**CHARTER TOWNSHIP OF VAN BUREN  
PLANNING COMMISSION  
February 23, 2022  
MINUTES**

**ITEM #1: 22-005 – TEMPORARY CONCRETE BATCH PLANT – 39670 ECORSE ROAD**

RE: Review of Temporary Land Use Request #22-005 – Ajax Paving I-275 Batch Plant Proposal

DATE: February 18, 2022

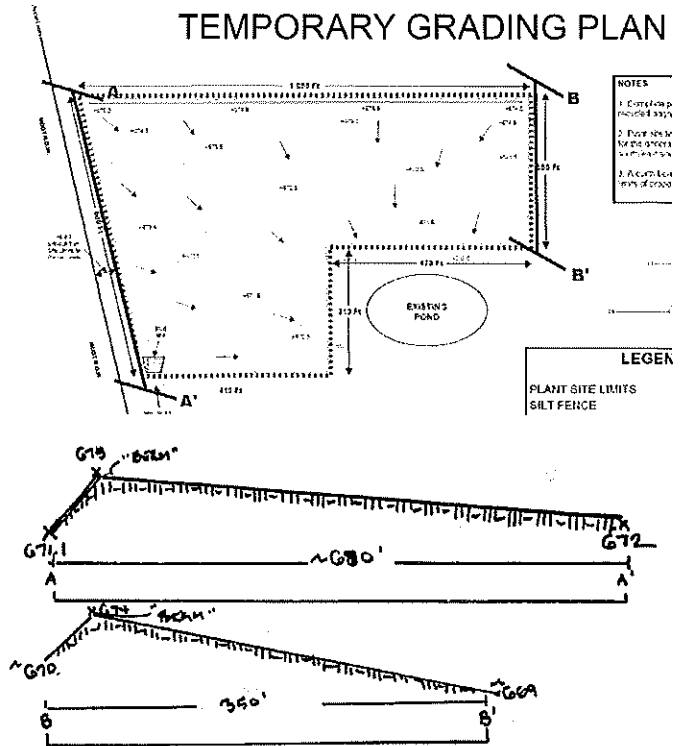
The applicant has provided a preliminary temporary grading plan which demonstrates stormwater runoff will be graded to run from the north to the south-southeast corner of the site. The grading plan does not show details regarding how the site ties in with surrounding sites. See image to the right for a general idea of what the grading plan conveys. This is particularly important to the north of the proposed site, which is covered with dense woodlands some of which are wetlands which are currently under review by EGLE. The plan shows that there will be a berm along this edge of the site but does not show dimensions or grading details for the berm. A conceptual detail showing the berm being 2' tall has been provided. The preliminary grading plan must be revised to show topographic contours across the project site and show the topographic relationship between the site and the surrounding grade to the north. The section drawing of the proposed berm should be to scale. These details should demonstrate that the site's drainage will not impact the adjacent woodland area to the north.

The proposed grading plan relies on stormwater runoff draining in a sheet flow pattern to an existing pond with no outlet to a downstream drainage course. The proposed temporary use will involve removing a vegetated surface and paving the site with "recycled aggregate". The proposed grading will be temporary. Following this site's temporary batch plant use, the site is planned to be excavated and then filled to a height significantly above the current grade as part of the expansion of the Woodland Meadows landfill.

4. The preliminary grading plan must be revised to show topographic contours across the project site and show the topographic relationship between the site and the surrounding grade to the north. The section drawing of the proposed berm should be to scale.
